Access Compliance Report

Public Rights-of-Way

(Curb Ramps)

Intersection ID: 12739	Main Street: N_MCDOWELL_ST	Cross Street: E_8TH_ST	Location: S
ADA ID: 7D186A7650F7	Ramp Type: PerpDiag	Initial Pass/Fail: Pass	Overall Compliance: No
Severity Score: 0.25			
Codes/Mitigation Info/Possible Solution		Field Measurements/Component Compliance

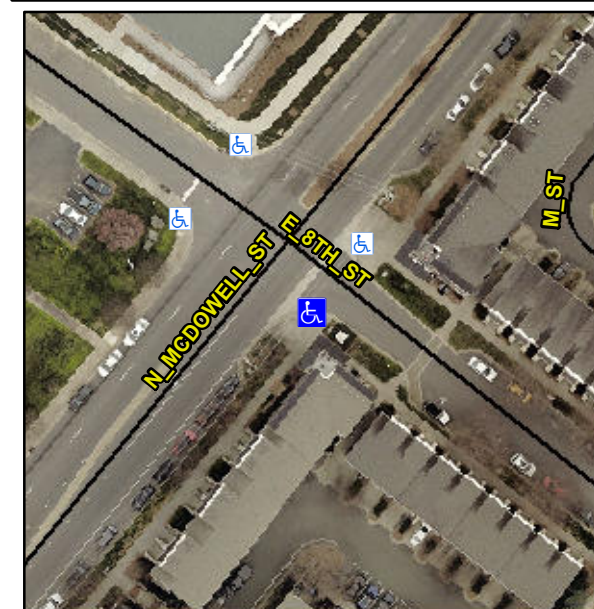
R304.5.3

Compliance	Description	Data	Compliance	Description	Data
N/A	Ramp Length (in)	74.0	Yes	Ramp Slope (%)	8.0
Yes	Ramp Width (in)	48.0	No	Ramp XSlope (%)	3.5
N/A	Flare Type LT	Sloped	N/A	Flare Type RT	N/A
N/A	Flare Slope LT (%)	9.4	Yes	Flare Slope RT (%)	9.0
N/A	Flare Traversable LT?	No	N/A	Flare Traversable RT?	Yes
Yes	Landing Length (in)	60.0	Yes	DWS Provided?	Yes
Yes	Landing Width (in)	60.0	Yes	DWS Contrast?	Yes
Yes	Landing Slope (%)	1.0	Yes	DWS Length (in)	24.0
Yes	Landing X Slope (%)	0.7	Yes	DWS Full Width?	Yes
N/A	Landing Curb? (Y/N)	No	Yes	DWS Offset (in)	2.0
N/A	Shared Landing?	No			
Yes	Gutter Ponding?	No	Yes	Gutter Slope (%)	1.5
Yes	Gutter Lip Ht (in)	0.0	Yes	Gutter X Slope (%)	1.6
N/A	Painted X Walk1?	No	N/A	Painted X Walk2?	No
	X Walk 1 Direction	To NE		X Walk 2 Direction	To NW
N/A	X Walk 1 Width (in)	N/A	N/A	X Walk 2 Width (in)	N/A
	X Walk 1 Slope (%)	0.9		X Walk 2 Slope (%)	0.4
	X Walk 1 X Slope (%)	0.3		X Walk 2 X Slope (%)	1.5

Remove & Replace Curb Ramp With Two New Directional Ramps or Equivalent.
